<b>TAL-CO SUPPLEMENTAL INSTRUCTION #60</b>			
<b>EV CHARGER LOCATIONS - REVISED SIDEWALK LAYOUT</b>			
Project Name:	<b>RW TOMLINSON - NEW HEAD OFFICE</b>		
Project Location:	<b>100 CitiGate Drive, Ottawa, Ontario</b>		
ARCH. SI #:	<b>N/A</b>	Issued By:	<b>Chris Simpson</b>
STRUC. SI #:	<b>N/A</b>	Date Issued:	<b>September 26, 2017</b>
MECH. SI #:	<b>N/A</b>	Revision #:	<b>N/A</b>
ELEC. SI #:	<b>N/A</b>	Revision Date:	<b>N/A</b>

**TITLE: EV CHARGER LOCATIONS - REVISED SIDEWALK LAYOUT**

PROJECT: TOMLINSON NEW BUILDING  
4501 STRANDHERD DRIVE

DRAWING TITLE: EV CHARGER LOCATIONS  
REVISED SIDEWALK LAYOUT

1 2000 REVISED SIDEWALK LAYOUT

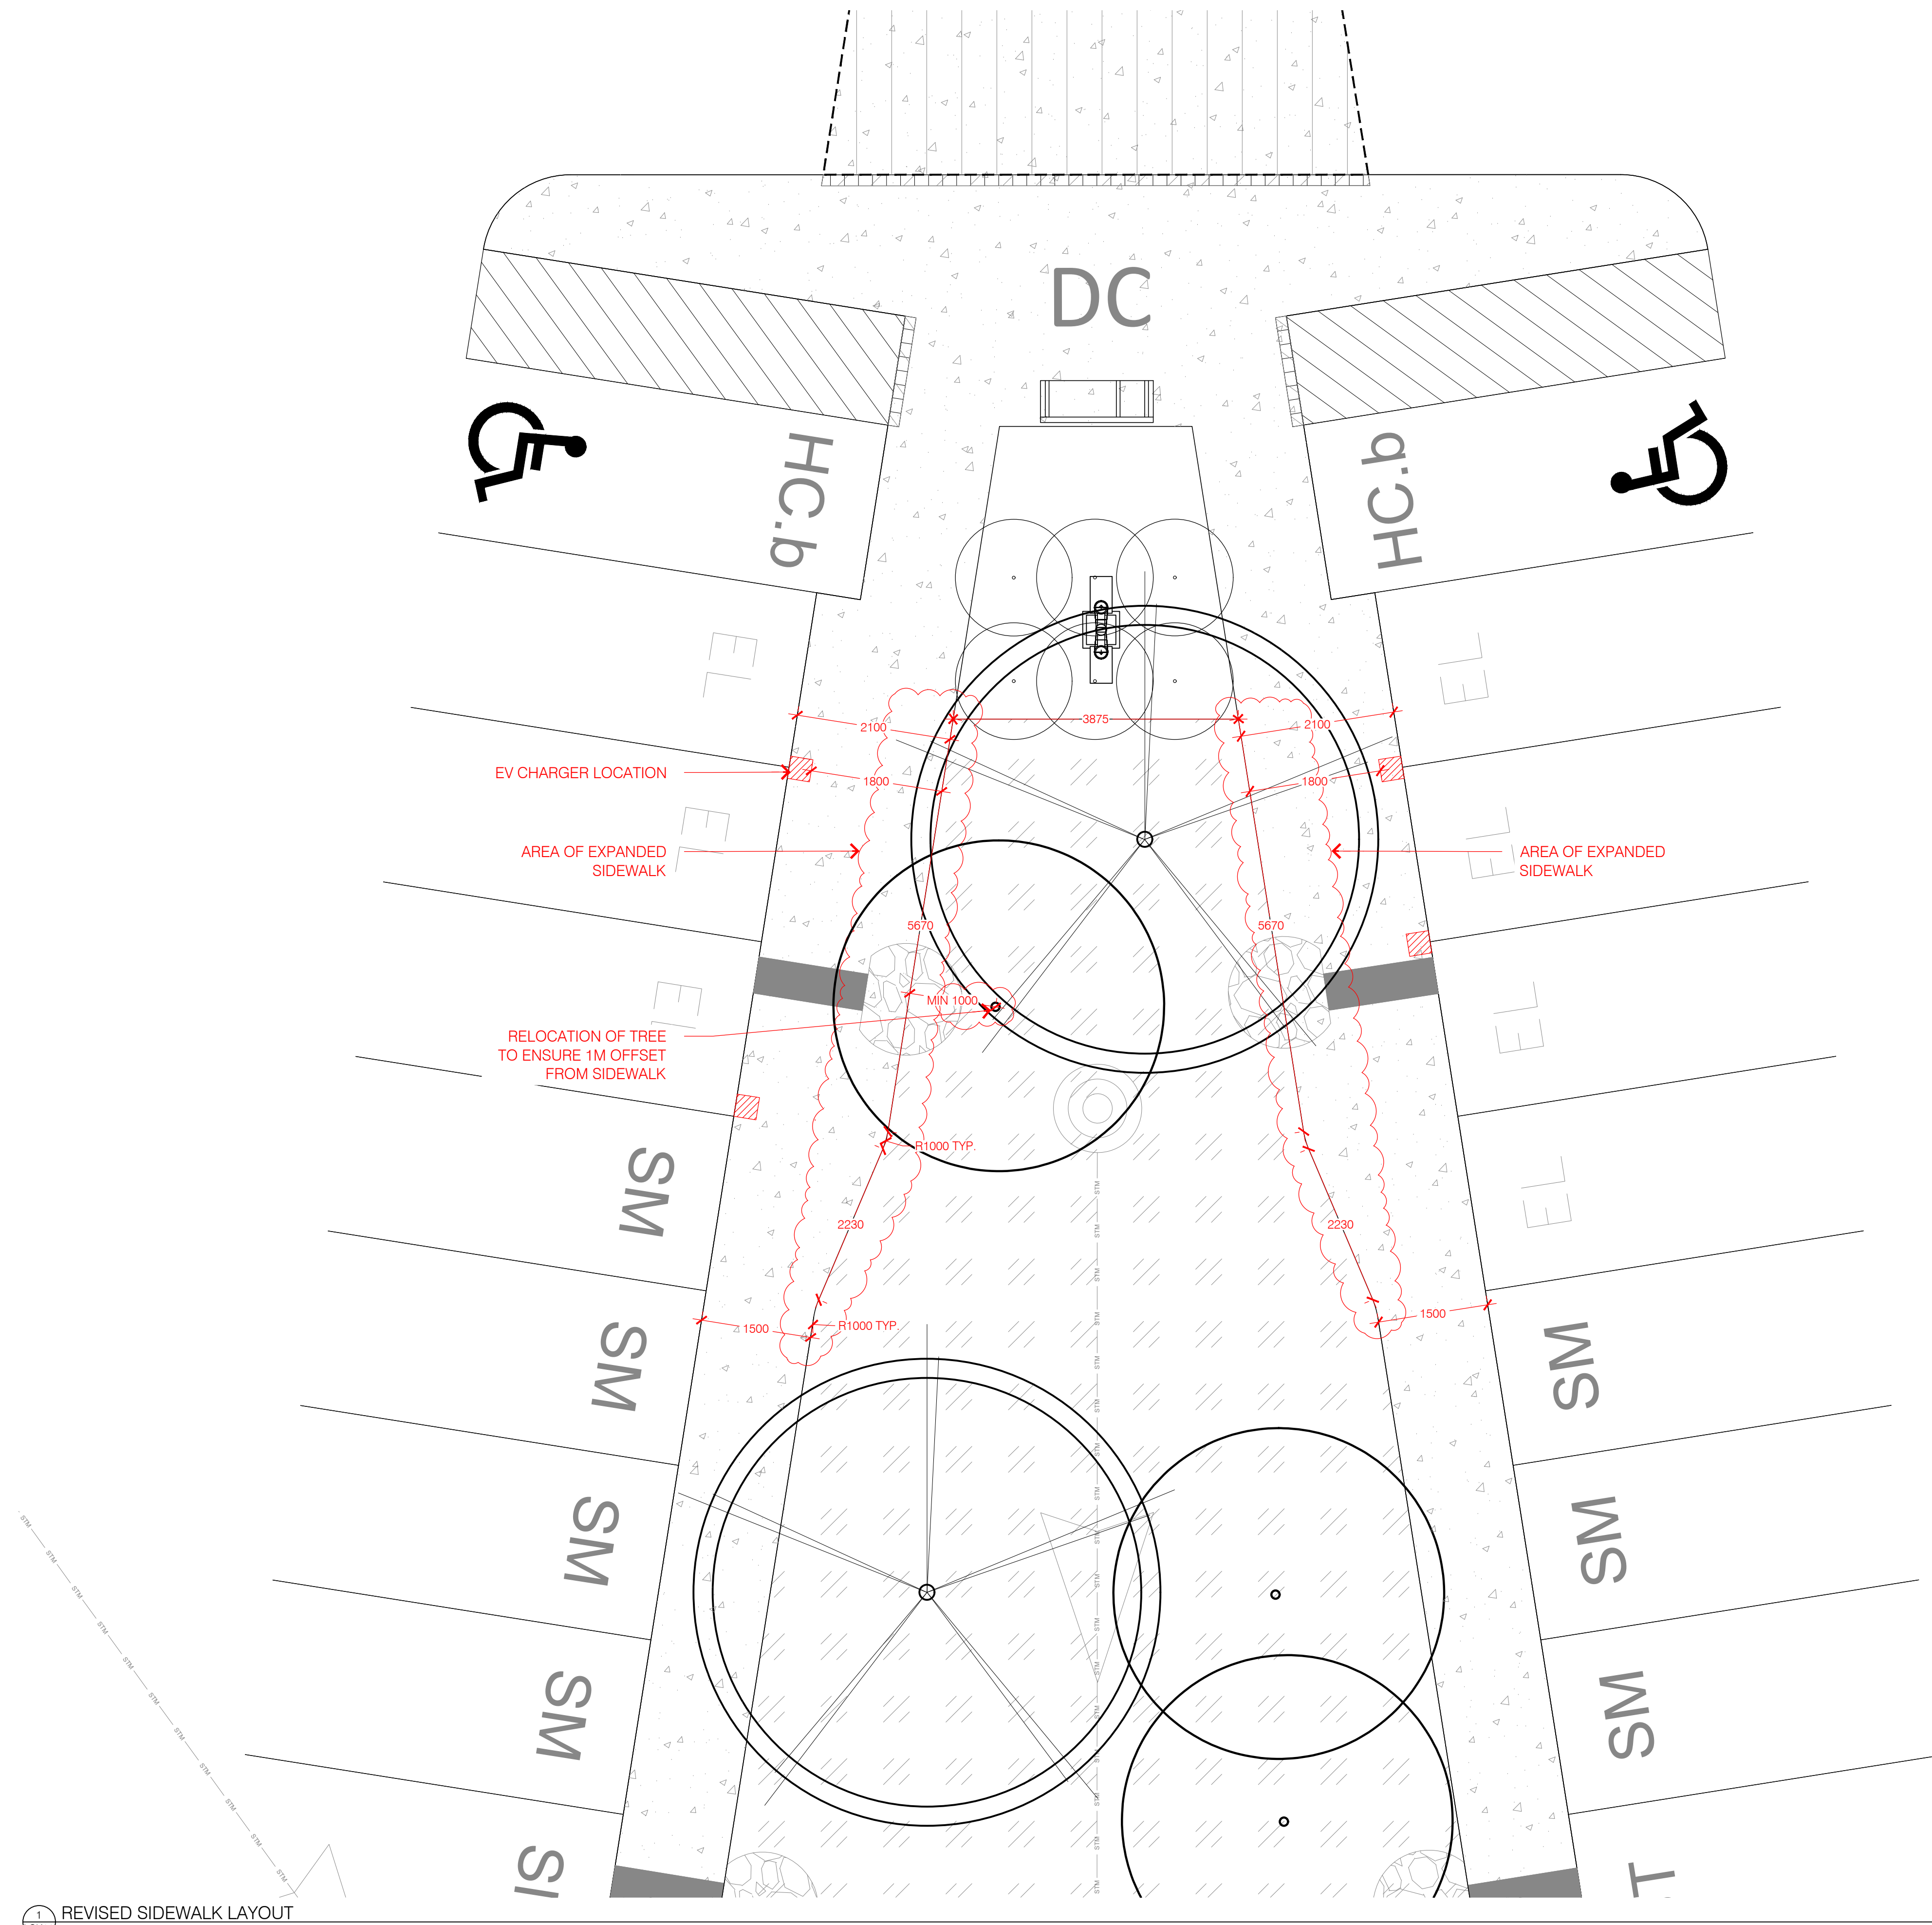
Sketch to provide revised sidewalk detail, and to identify EV Charger Pedestal locations.

Sidewalk size increased to accommodate EV Charger Pedestals.
